Re: St. Lucie Plant Unit 2
Docket No. 50-389
Renewed Facility Operating License No. NPF-16

Response to NRC Request for Additional Information (RAI) Regarding Extended
Power Uprate License Amendment Request

**Response to NRC Nuclear Performance and Code Branch
Request for Additional Information**

SNPB-16

Figure-27
Large Break LOCA ECCS Performance for Limiting Seismic Loads Analysis
0.6 DEG/PD Break
Peak Cladding Temperature

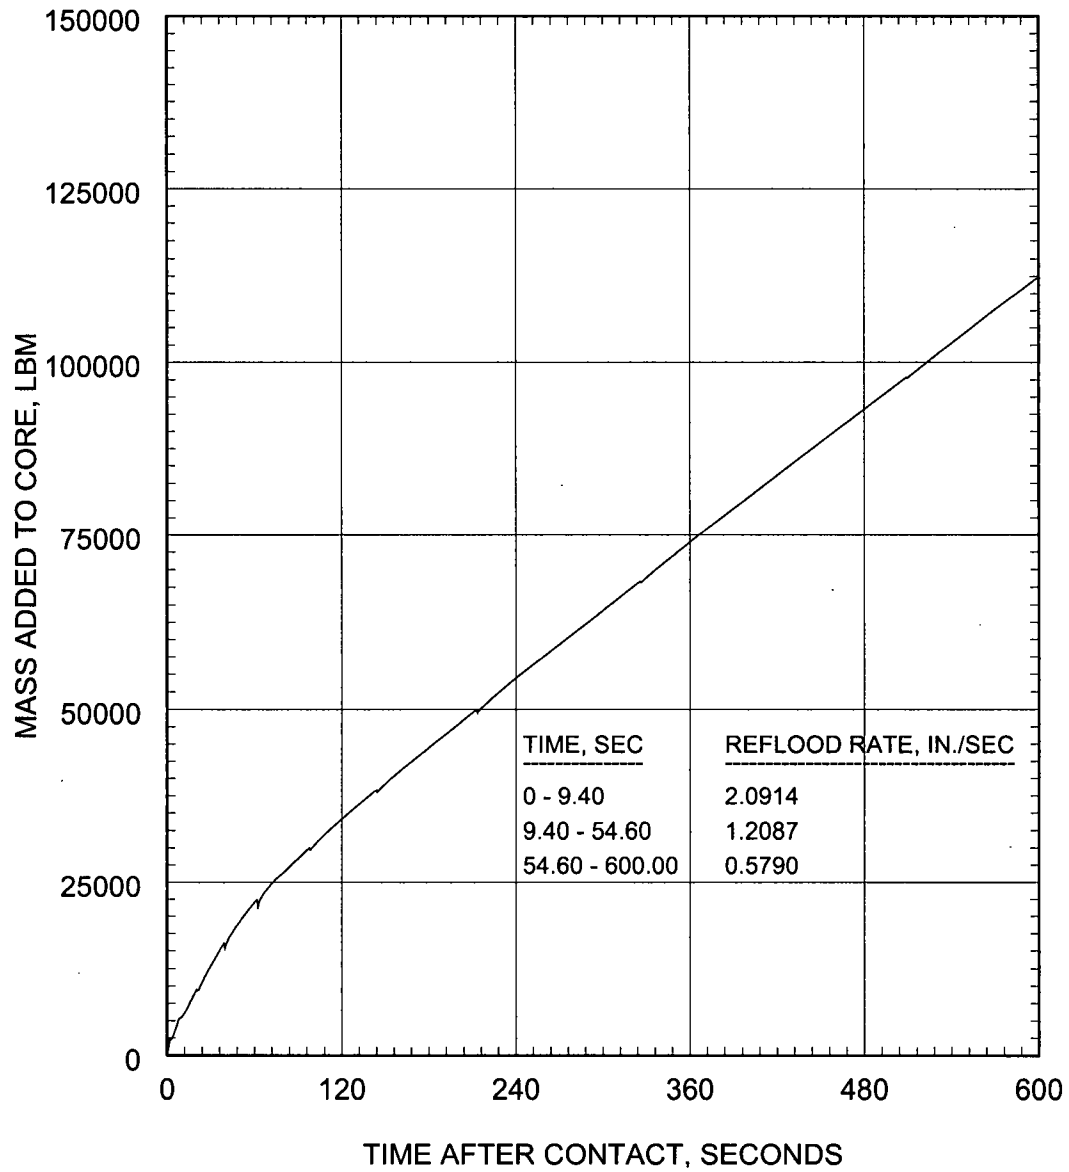
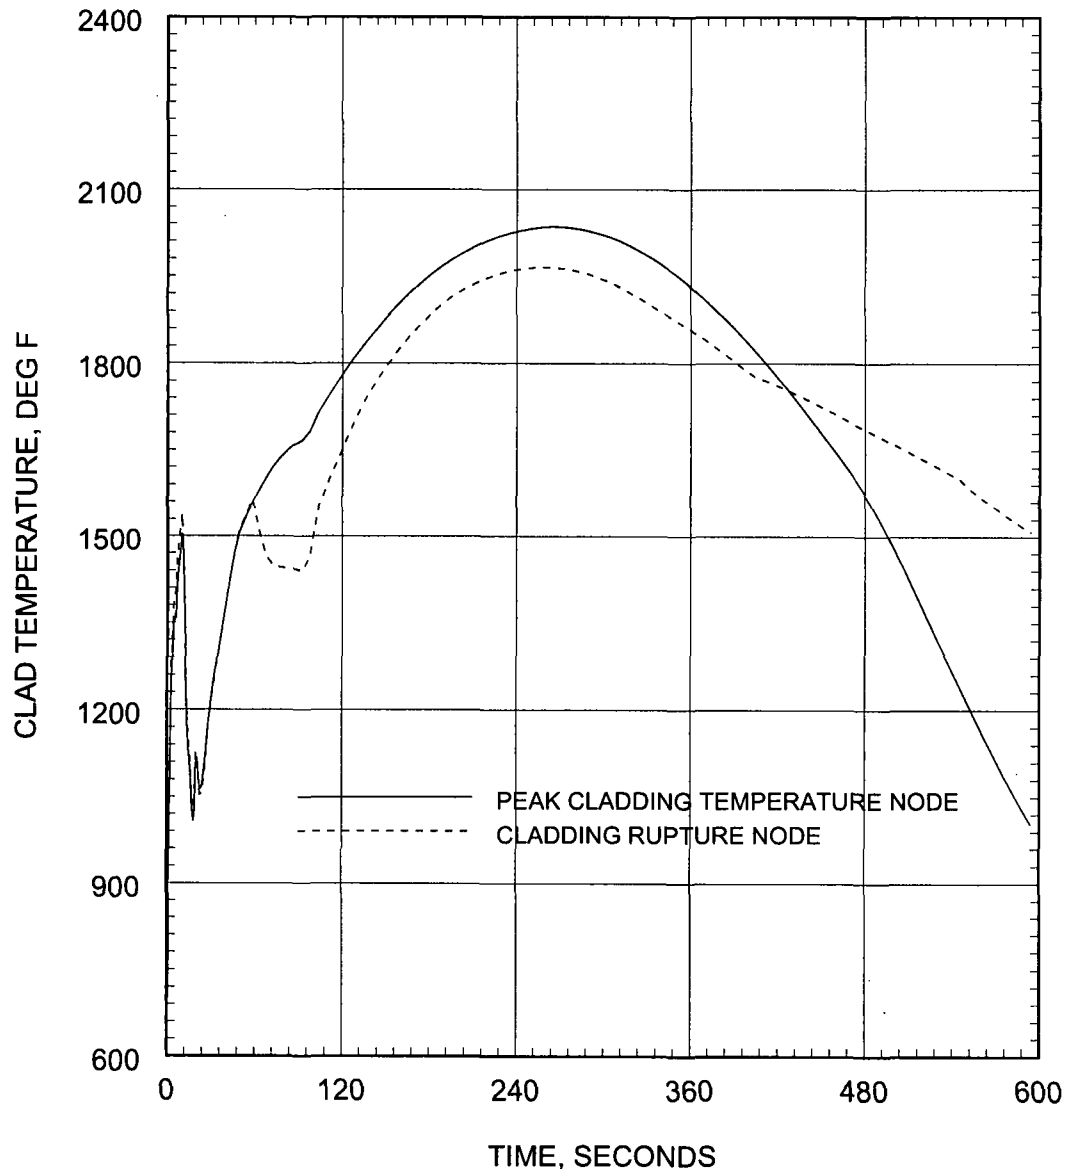
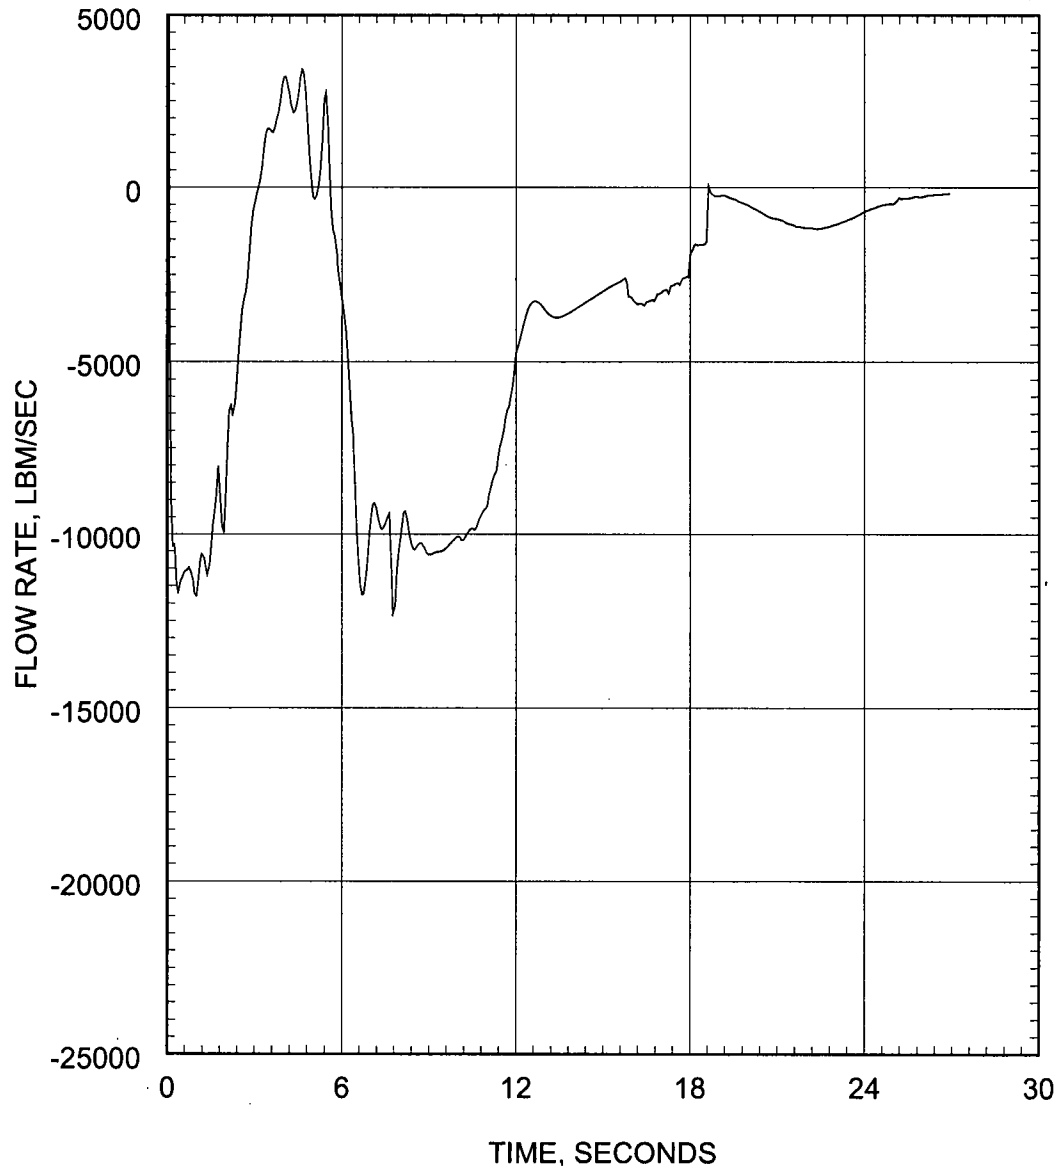
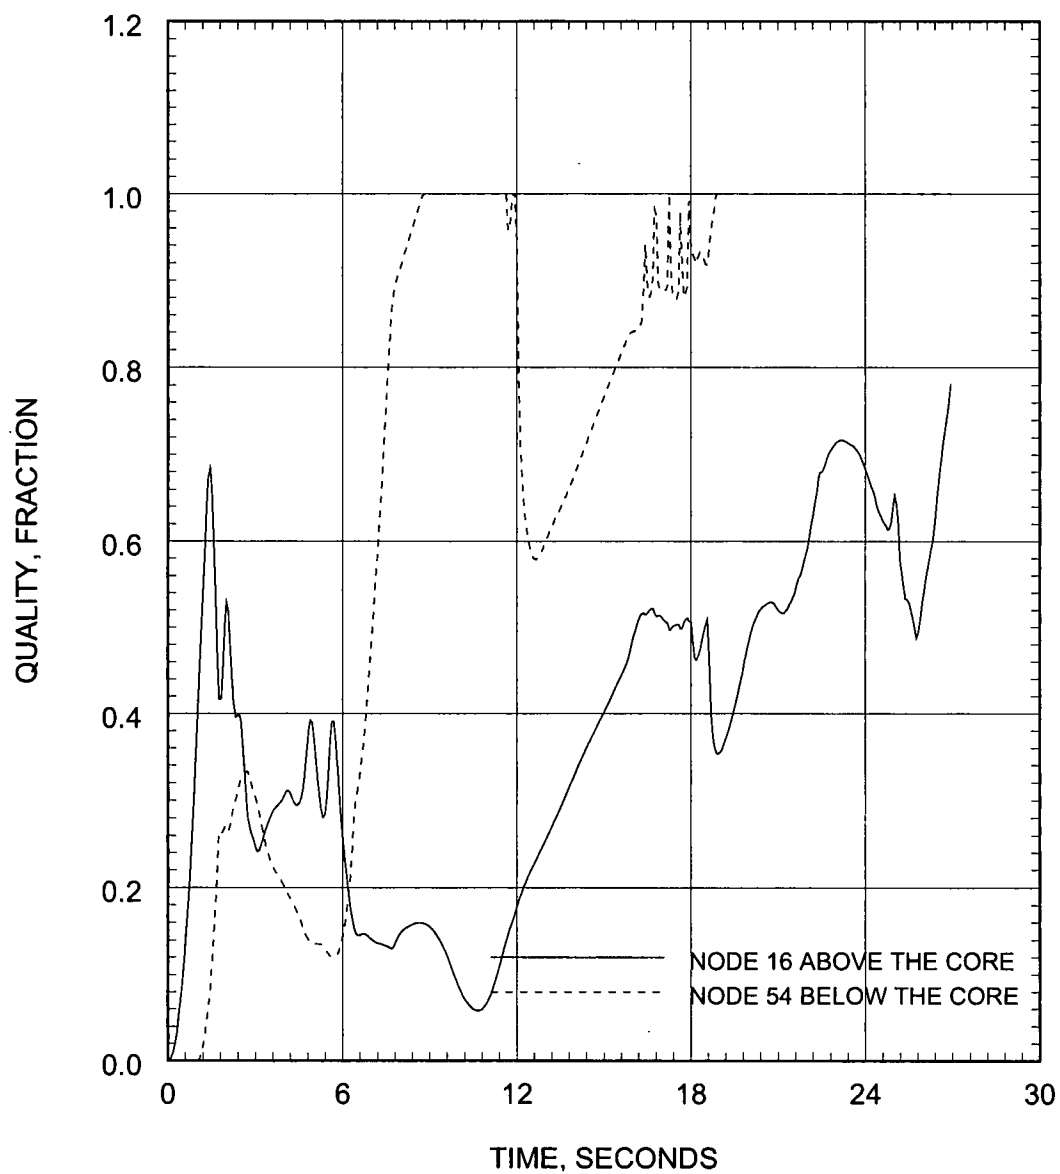
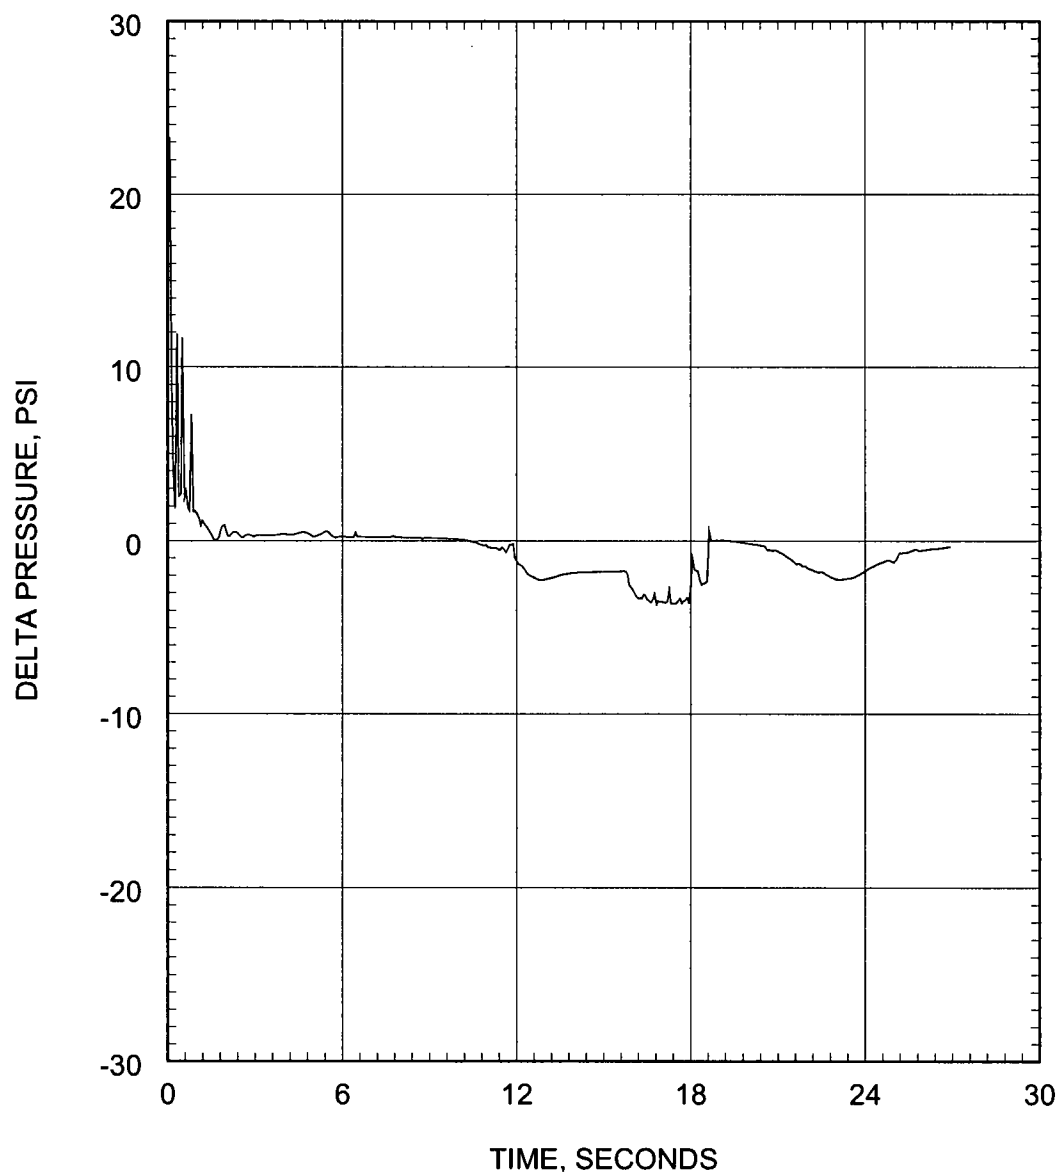
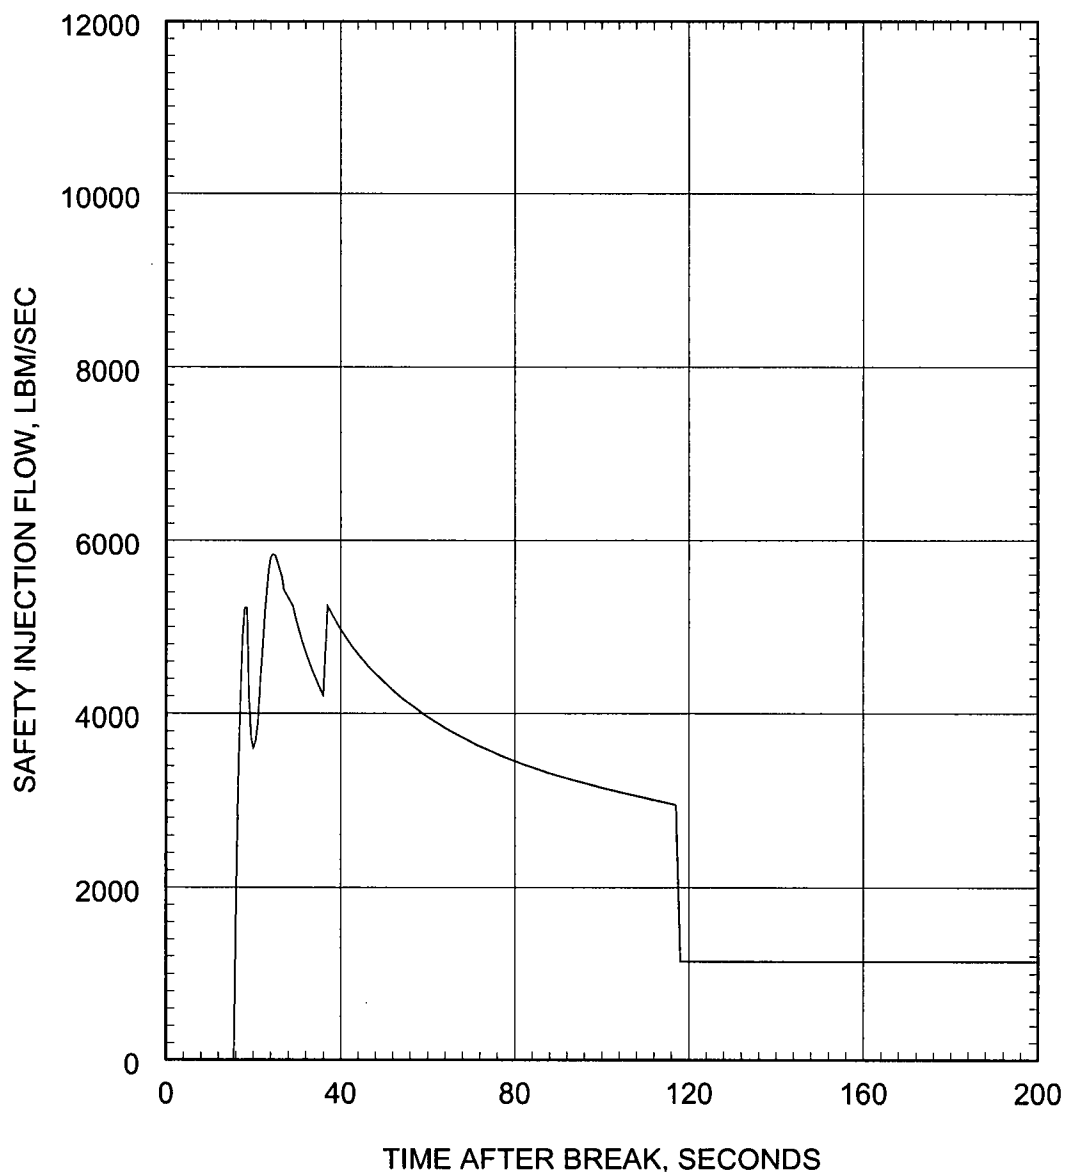
Please provide the results of the seismic LOCA loads analysis for the limiting break. Identify the maximum hot channel deformation/flow area reduction, the maximum hot bundle flow area reduction, the peak linear heat rate for the hottest rod in the assembly undergoing maximum deformation. Also, provide the linear heat rate for the bundle containing the rod with the max deformation. The analysis should provide the plots typical of the limiting large break LOCA analysis given in a chapter 15 analysis.

The seismic LOCA loads analysis confirms that 10CFR50.46 criteria related to peak cladding temperature and maximum cladding local oxidation criteria are satisfied for LOCA analysis of hot rods in peripheral fuel assemblies with maximum credible grid deformation, i.e., fully collapsed grids. The LOCA analysis is performed with the 1999 EM and conforms to guidelines for the evaluation of fuel assembly structural response to externally applied forces specified in NUREG 0800, SRP 4.2, Appendix A, Section IV, related to requirements from 10CFR50.46 ECCS Performance design basis criteria and use of maximum credible grid deformation. The maximum allowable LHR in peripheral distorted assemblies is determined to be 95% relative to the maximum LHR in the core.

The variables listed in Tables 2 and 3 are plotted as functions of time for the 0.6 DEG/PD break, the limiting LBLOCA, in Figures 19 through 38.
